# LIGHTING SUB PLAN

## Moorebank Precinct East Stage 2

## Lighting Sub Plan

Author	Katrina Nestmann
	Shannon Blackmore
	Zachary Quintal
	Bruce Layzell (Arcadis)
	Luke Nichols (Modcol Pty Ltd.)
	Brett Whiteford (Osiris Enterprises)
Checker	Eric Chen (C-Level)
	Heather Tilley
Approver	Ketan Patel
Report No	SSS2-QPMS-EN-APP-00036
Date	3/11/2020
Revision Text	008

Figure 1-1: Site Location

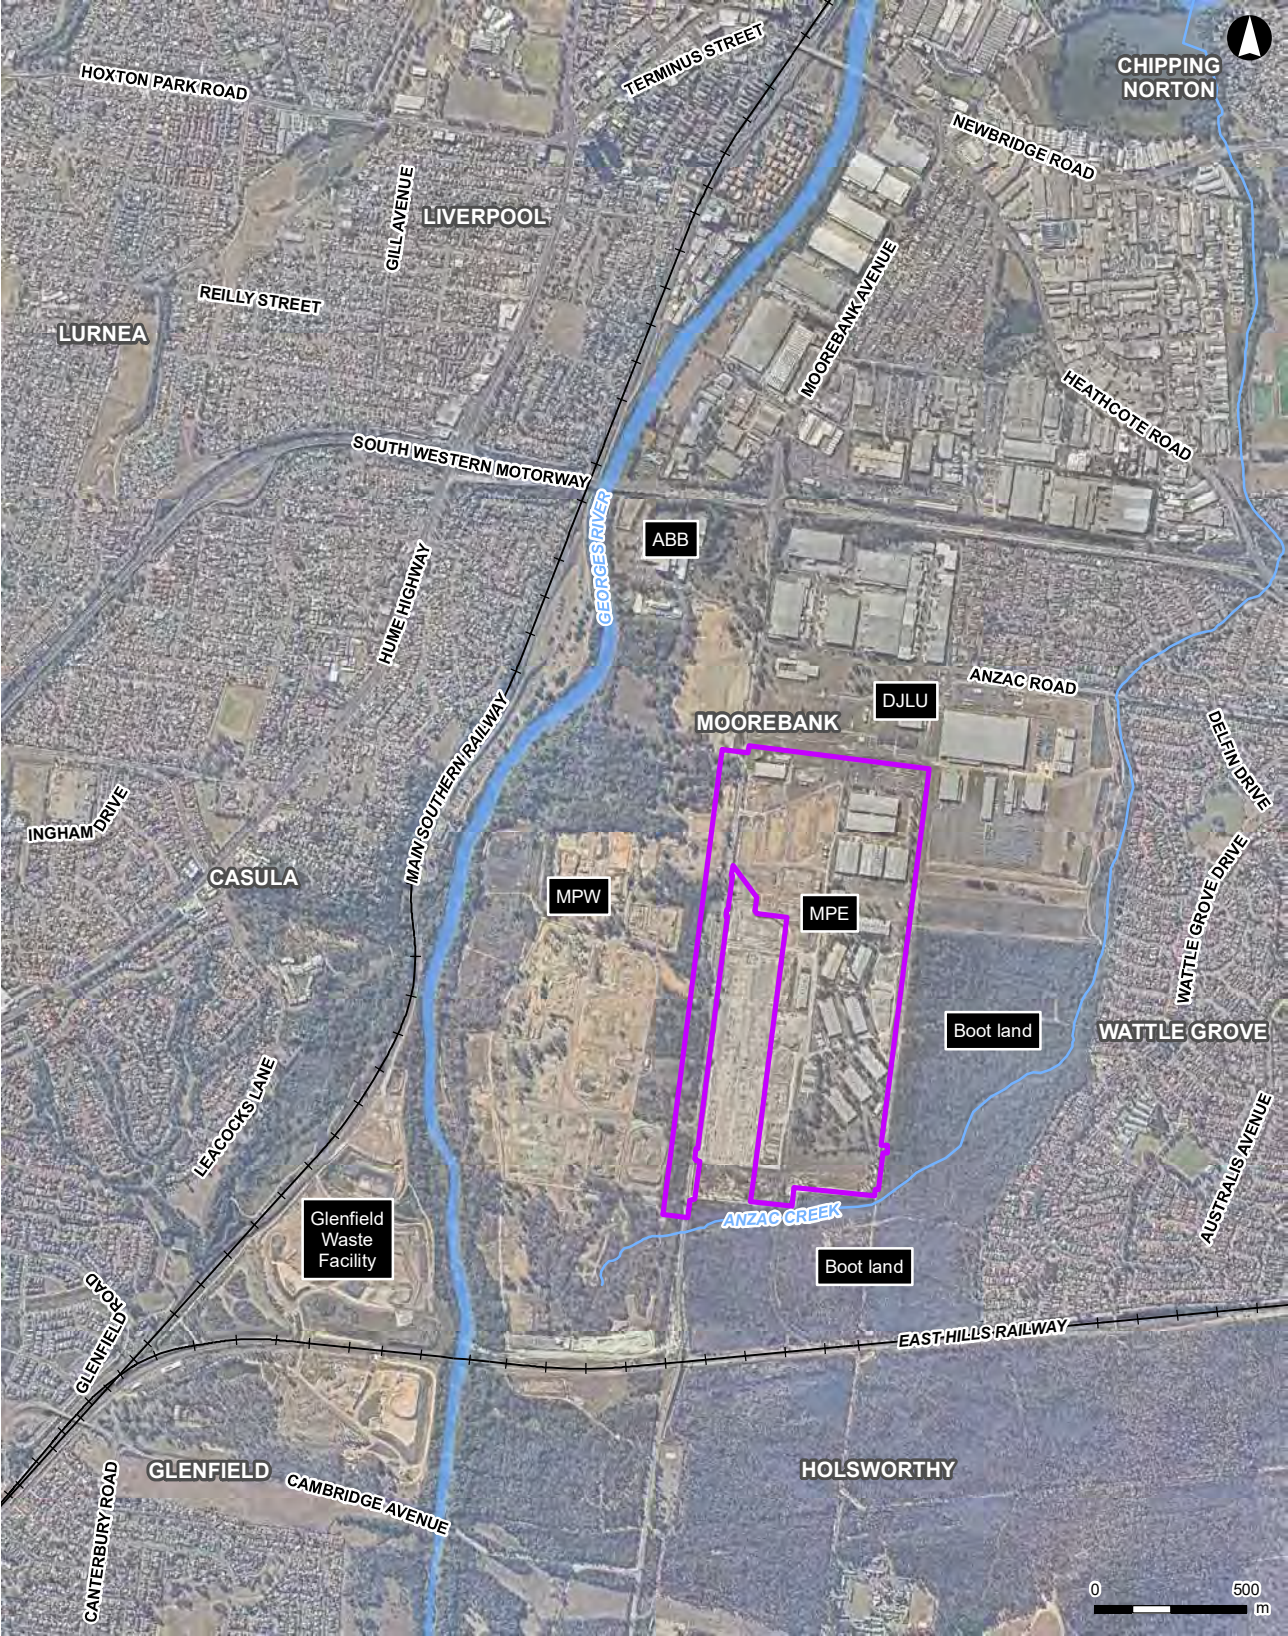
CoC	Requirement	Section Reference	DPE Comment (Rev 2, dated 9/08/2018)	Proponent Response	DPIE Comment (Rev 003, dated 15 March 2019)	DPIE Comment (Rev 006B, dated 08 March 2020)	Proponent Response July 2020.
			nuisance to the public road network.			<p>ranging from 6 to 12m and capped at 13.5m including the car park. LED pole lights in the warehouse yard will be directed downwards, using shielded fittings with a beam angle of 10°. Lighting types are listed and luminaire schedules differ. Details are referenced in Appendix A2.</p> <p>Section 2.2.2.2 (Area 2) lists lighting locations and states that control of external lighting will be via a programmable system which with a timed on/off clock, a photoelectric sensor and an override switch.</p> <p>Lighting types are listed together for WHs 3 &amp; 4 and separately for WH5 and luminaire schedules differ. Within the warehouse areas lighting will be mounted at heights of 3 m to 9m, directed downwards and use specific cut off luminaires which would eliminate upward light spill above the horizontal. The high efficiency LED lights will tilt between 0° to 20°. Details are referenced in Appendix B2.</p> <p><b>DPIE Comment: Please update plan to include Figure 1-1.</b></p>	The LSP has been amended to include Figure 1-1.

PIWE-ULT-EL-DWG-0102

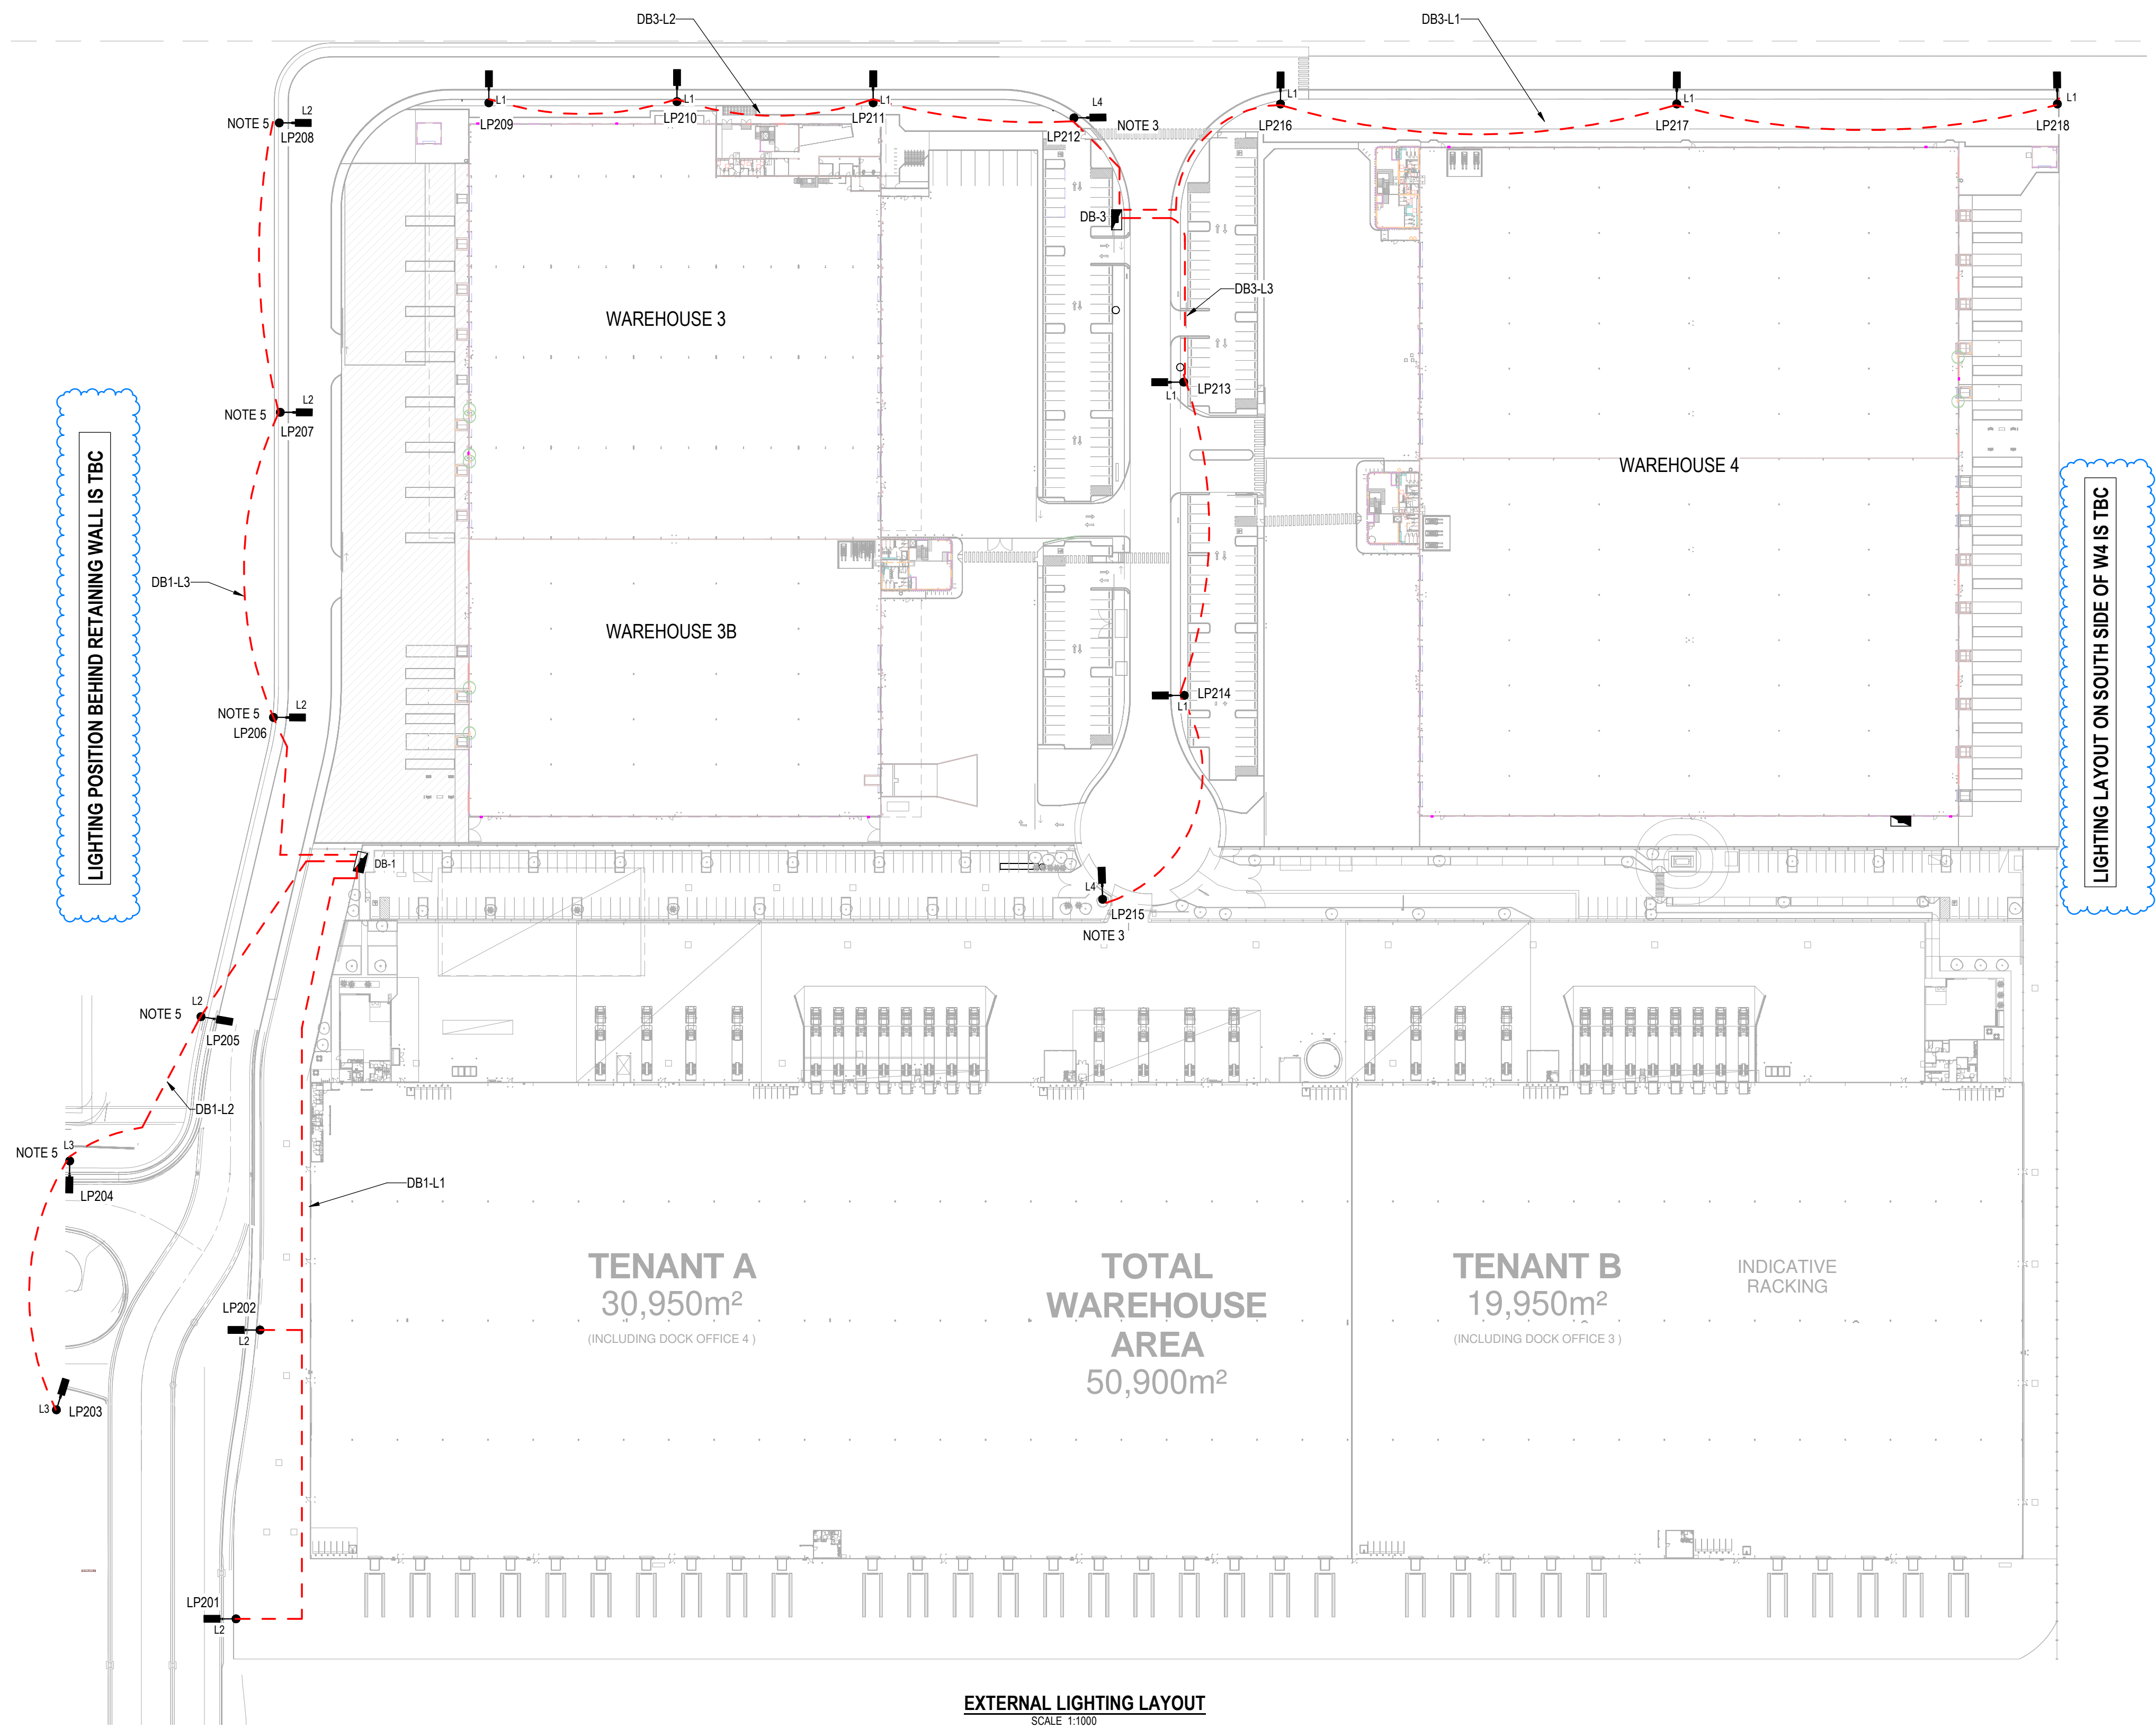
Appendix 2, Drawing No. PIWE-UTL-EL-DWG-0102 shows the positions of the light towers around Area 2, while Drawing No. 1601, shows the lux extent of the lighting design of Area 2.
